# SERVICE BULLETIN

ENGINE - NO.4 BEARING COMPARTMENT - PROVIDE A NO.4 BEARING COOLING DUCT AND HEATSHIELD WITH IMPROVED SEALING FEATURES - CATEGORY CODE 7 - MOD.ENG-72-0097

V2500-ENG-72-0097

Location of the No.4 Bearing Heatshield and Cooling Duct Assemblies  
Fig.1

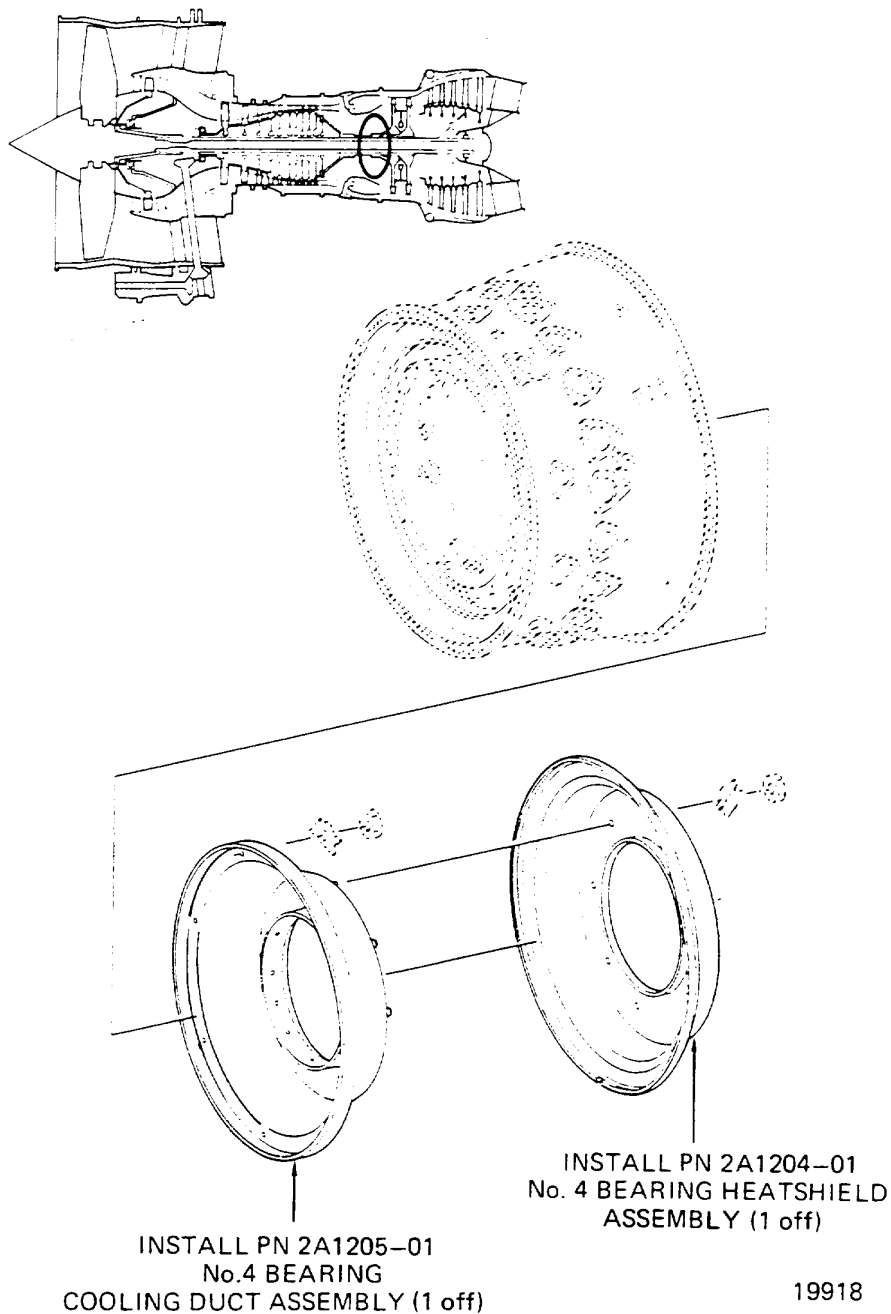
- (1) A new No.4 Bearing Compartment Cooling Air Duct and compatible Heatshield are introduced featuring improved design which will prevent debris ingestion and protect the No.4 Bearing Carbon Seal.

- (1) Install the 2A1204-01 No.4 Bearing Heatshield Assembly (1 off) and 2A1205-01 No.4 Bearing Cooling Duct Assembly (1 off). Use the approved procedure in Reference (3), Chapter/Section 72-00-43, Installation-01.
